# Technical Bulletin

**Model**  
911C2/C4

**Subject:** Front Fenders Tack-Welded

**Number**  
9001

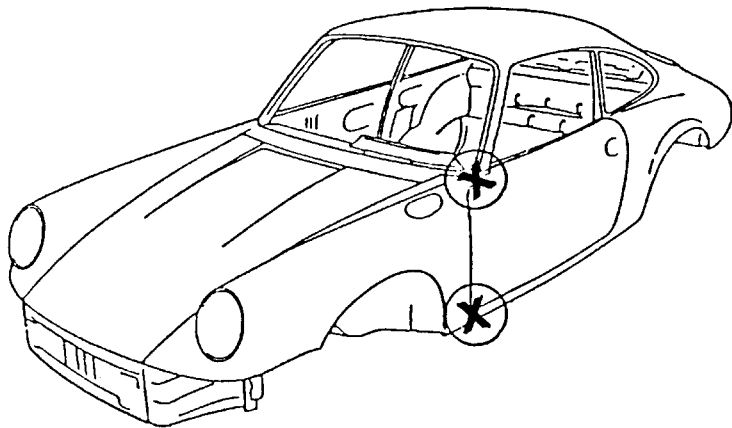
**Concern:** Front fenders are tack-welded in production.

**Repair Information:** When removing fenders, check for tack-welds and detach as necessary (maximum two weld points, "X" in figure).

When installing fenders, to ease installation and alignment, you may also tack-weld in the areas indicated by "X" in figure.
